**DRAWING AMENDMENTS:**

## REMARKS

Fig.4.

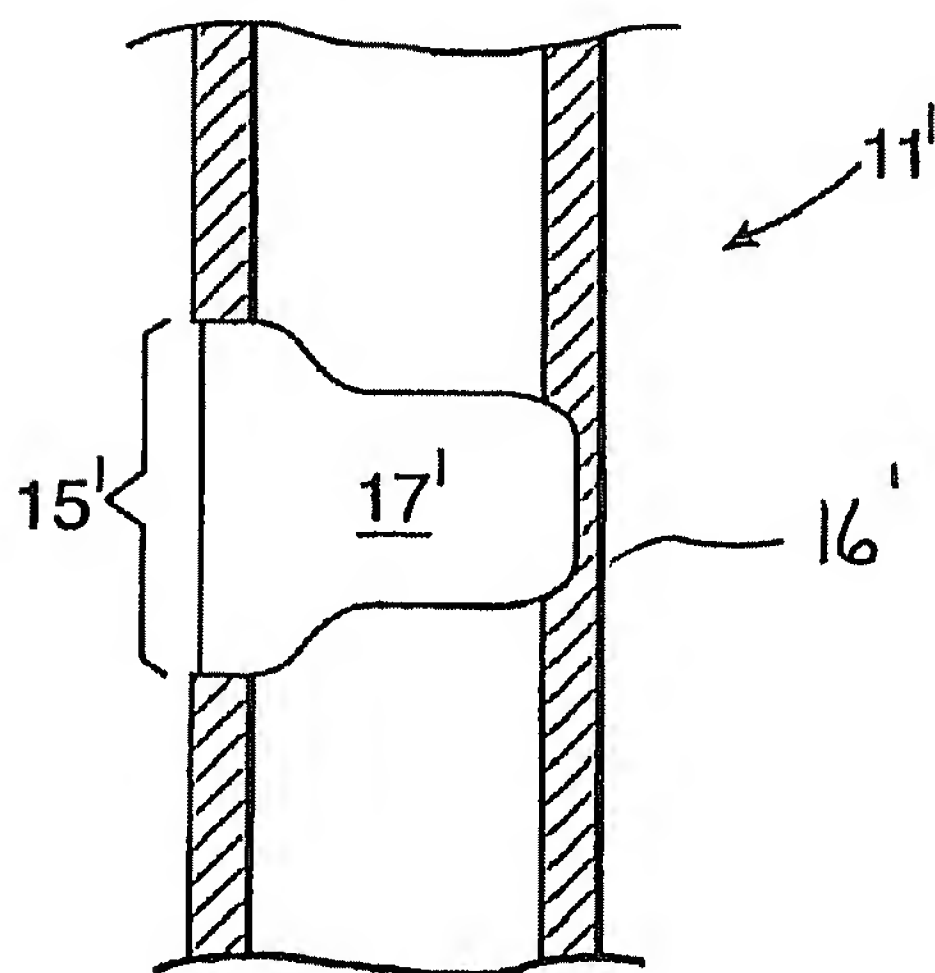
The examiner objected to the drawings for failing to include a reference numeral 16'.

ADD  
NUMERIC  
DESIGNATION  
16'

Figure 4 is amended herein to include the reference numeral 16'.

The examiner's objection is overcome by amending Figure 4 herein to include reference numeral 16'.
